NOTICE OF DECISION

PLANNING ADMINISTRATOR DECISION FOR SITE PLAN REVIEW

CASE TYPE: Class 2 Site Plan Review
AMANDA NO.: 22-119636-PLN
DATE OF DECISION: March 20, 2023
PROPERTY LOCATION: 3315-3365 Marietta Street SE
APPLICANT: Jordan Sparks
ZONE: IC (Industrial Commercial)
COMPREHENSIVE PLAN: Industrial
OVERLAY: None

**SUBJECT: PUBLIC WORKS RECOMMENDATIONS
CLASS 2 SITE PLAN REVIEW (22-119636)
3365 MARIETTA STREET SE
OFFICE AND DAYCARE BUILDING**

JORDAN SPARKS		BUILDING H CONSTRUCTION		SITE PLAN (NORTH)	
DRAWING C2.1		JOB NUMBER 2822.0000.0		DATE: AUG 2022	
DSN.	SAW	DRN.	AR	NO.	1
CKD.	SAW	NO.	1	DATE	
DESCRIPTION				REVISIONS	
BY

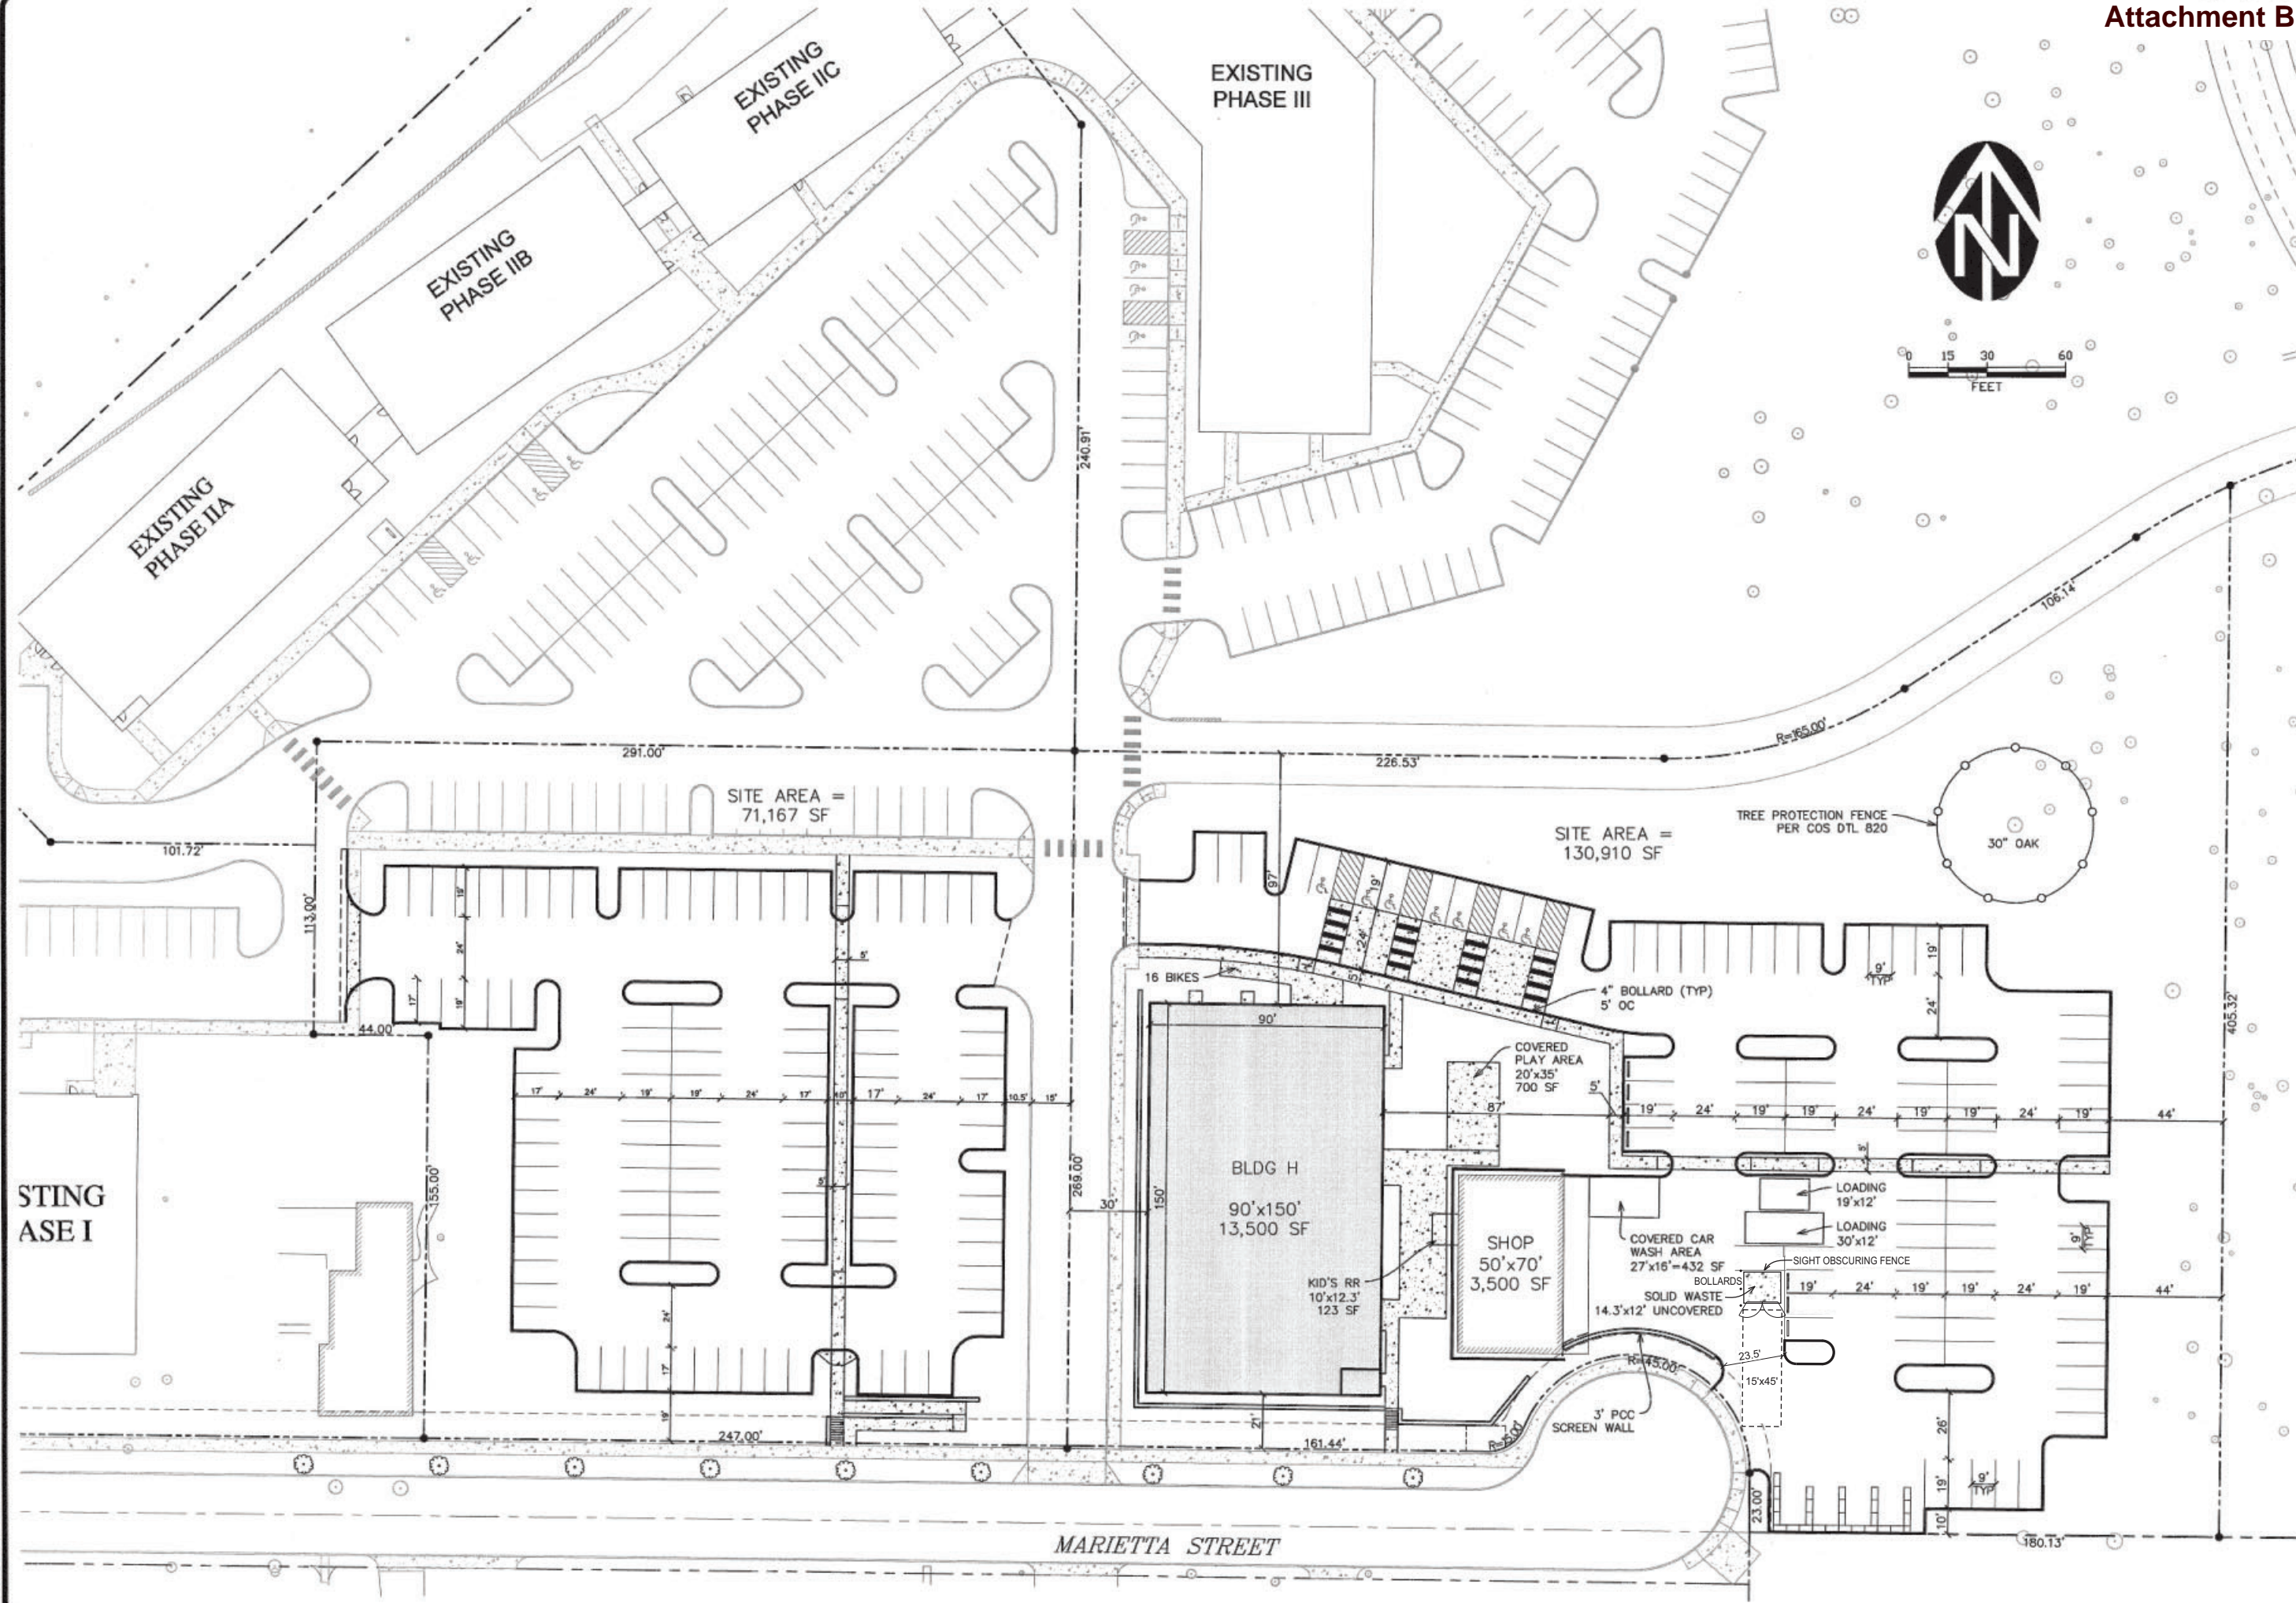
Finding: The proposed building on Lot 3 is setback 21 feet from Marietta Street SE to the south. There is an existing shop building on site, where no changes are proposed to the location of the existing building. The new vehicle use area on Lot 2 is setback 19 feet from the Marietta Street SE to the south. The proposal meets the standards.

two or more uses. Because these two lots are part of a larger development site and the interior property lines are located over shared driveways that provide access throughout the site, the five-foot landscaped setback is not required for most of the property lines involved with this proposal. However, the east property line of Lot 3 and a portion of the west property line on Lot 2 are not located over a driveway, and do require the five-foot vehicle use area setback. In both cases, the site plan indicates there is well over the five-foot minimum provided from the vehicle use area to the property line. The proposal meets the standards.

Finding: Lot 2 is approximately 71,167 square feet in size, requiring a minimum of 10,675 square feet of landscaped area ($130,900 \times 0.15 = 10,675.05$). The site plan indicates a total of 12,163 square feet (17.1 percent) of landscaped area is provided on site. Lot 3 is approximately 130,910 square feet in size, requiring a minimum of 19,637 square feet of landscaped area ($130,910 \times 0.15 = 19,636.5$). The site plan indicates a total of 38,678 square feet (29.5 percent) of landscaped area is provided on site. Each phase of the development site has been evaluated for the minimum 15 percent landscaping, providing at least 15 percent for the development site as a whole. Per the landscape totals provided under Case Number UGA-SUB-SPR-DAP-ADJ16-01, the following is an updated summary of the landscape area coverage for each lot of the development site:

Finding: The applicant's development plans show the proposed solid waste service areas will be screened with a six-foot-tall sight-obscuring chain link fence with slats and gates. The proposal meets the standard.

Finding: The proposed vehicle operation area shows an area 45 feet in length and 15 feet in width, perpendicular to the enclosure and extending into the cul-de-sac of Marietta Street SE, meeting the minimum dimensional requirements for service vehicle access.

Finding: The proposed site plan shows a vehicle operation within a parking lot drive aisle, where the plans indicate a direct approach into position and adequate room for a turnaround. The area will be kept free of parked vehicles and other obstructions; therefore, the proposal meets the standard.

Finding: The proposed off-street parking areas on both Lots 2 and 3 are greater than 25,000 square feet in size. The applicant's plans include a pedestrian connection on Lot 2 from an existing pedestrian walkway along the north side of the property, through the proposed parking lot and connecting to Marietta Street SE. The applicant's plans also include a pedestrian connection on Lot 3 from the far east side of the property, through the proposed parking lot and connecting to the proposed building, and extending around the building to provide pedestrian access to Lot 2 and Marietta Street SE. This standard is met.

Finding: The pedestrian connections proposed measure at least five feet in width in all locations. The type of material proposed for the pedestrian connections is not listed in the application materials. At the time of building permit, the applicant shall demonstrate that all applicable standards of this section are met.

Finding: The application materials do not provide sufficient detail to determine compliance with this development standard. To ensure compliance, the following condition applies.

Finding: The applicant's site plan including construction details for the 16 bike parking spaces to be installed on the north side of the new building, meeting the minimum dimensions, design, location and access requirements for this chapter. This standard is met.

Finding: The applicant’s site plans identify one significant Oregon White Oak Lot 3 that is designated for preservation with the appropriate protection measures. There are no other significant trees and no existing trees designated for removal on the portion of the subject properties where the proposed development activity is located. The proposal conforms to the requirements of SRC Chapter 808.
